GROUP	MODEL
Emissions Service Campaign	2022MY Seltos (SP2), Soul (SK3)
NUMBER	DATE
SC224	March 2022

VOLUNTARY EMISSIONS SERVICE CAMPAIGN

SUBJECT: **ENGINE OIL FILLER CAP REPLACEMENT (SC224)**

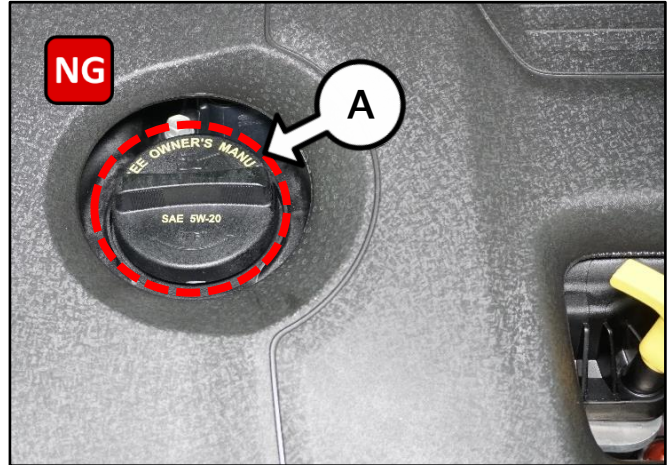
This bulletin provides information to replace the oil filler cap on some 2022MY Seltos (SP2) and Soul (SK3) vehicles produced in the date ranges listed below, which may have an oil filler cap with the incorrect viscosity description ("SAE 5W-20", correct description: "SAE OW 20"). Follow the procedure outlined in this publication to replace the oil filler cap with the correct part. Before conducting the procedure, verify that the vehicle is included in the list of affected VINs.

Incorrect Oil Filler Cap
(SAE 5W-20)

Correct Oil Filler Cap
(SAE OW 20)

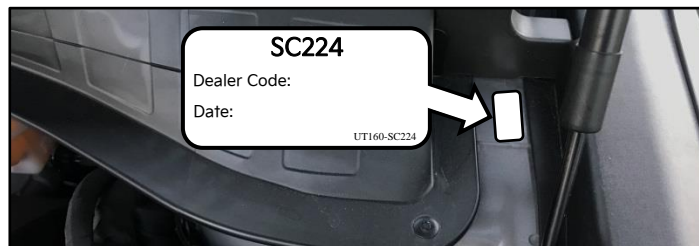
The dealer must fill in the Dealer Code and Date information fields on the Campaign Completion Label. Once complete, affix the campaign completion label under the hood of the vehicle, as shown below.

CA and S.177 States Only: Apply SC224 Campaign Completion Label onto the body in the area next to the shock tower, as shown. **NOTE: Be sure to clean the mounting surface to ensure proper label adhesion.**
